Statement of Environmental Effects

Section 4.55 (2) Application

2 Macpherson Street, Warriewood

Amend Building Envelope Plan

Figure 4: Proposed Building Envelope Plan (Source: Annexure 1)

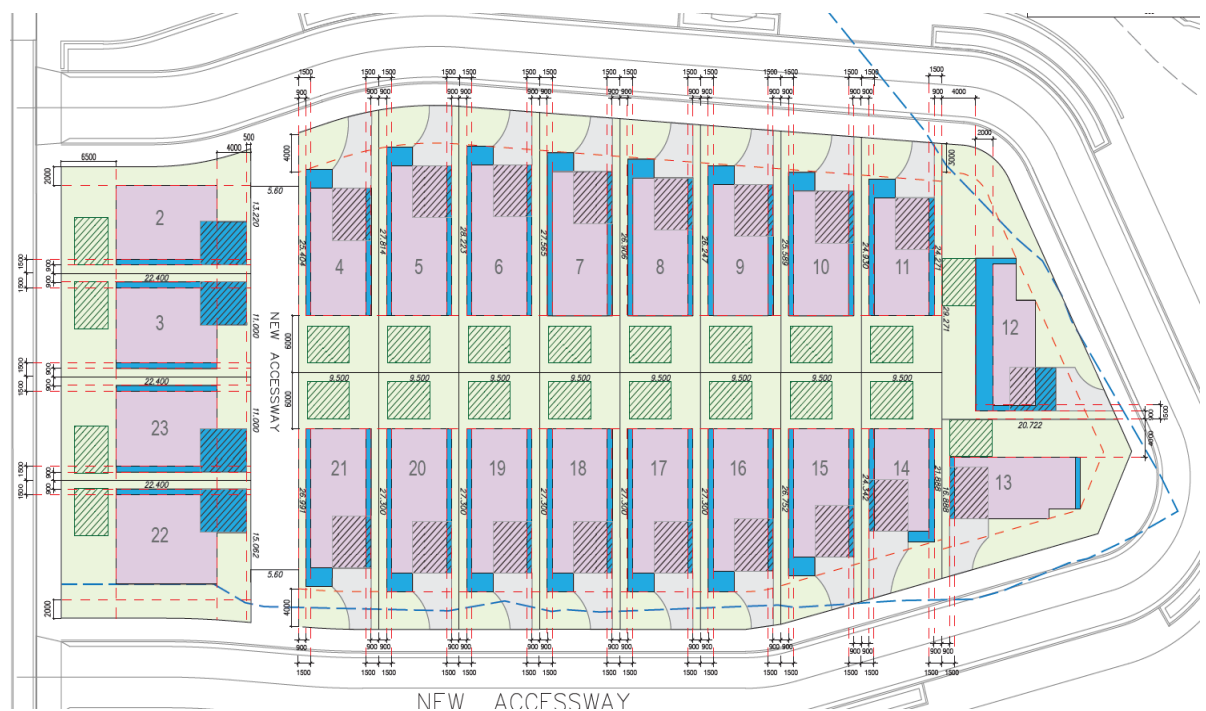
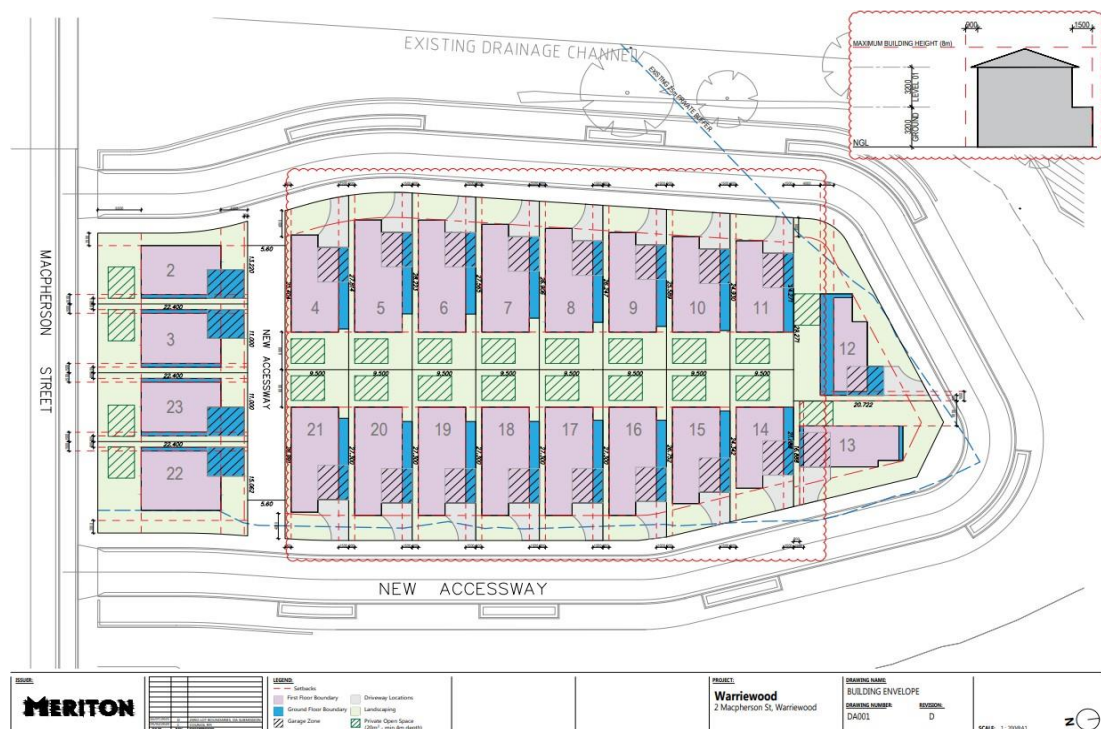
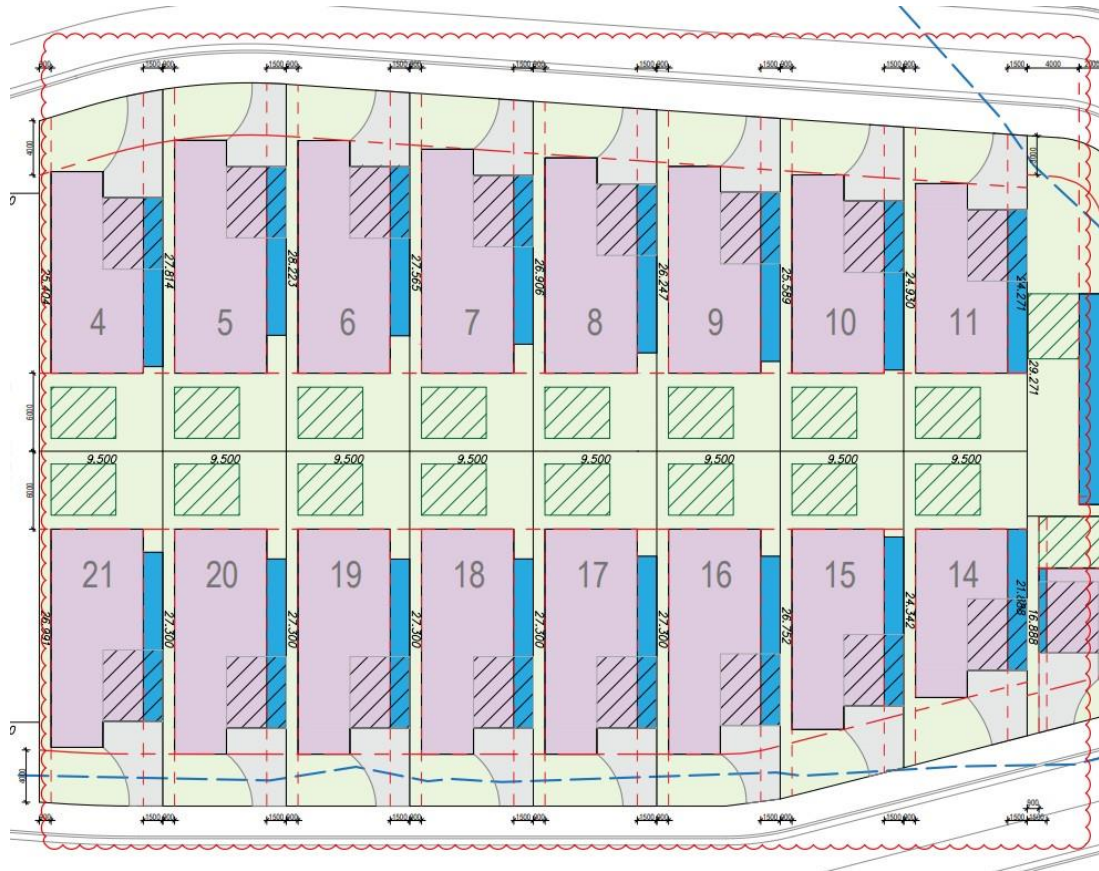
Further detailed design has established that the revised building envelopes make for an efficient use of the site, noting the large front and rear setbacks already in place. It is proposed the 16 allotments, being lots 4 – 11 and 14 – 21, will have the following setbacks introduced:

- 900mm on the southern side applying to both ground level and first storey.
- Zero setback to ground level on northern side, while maintaining 1500mm setback to first storey.

It is noted that these allotments already provide for generous front and rear setbacks, with private open space requirements exceeding those normally required. Additionally, the proposed side setbacks on the southern side of the ground level will remain, ensuring separation between the buildings as originally intended. The proposed modifications are reflected in **Figures 4 and 5** below.
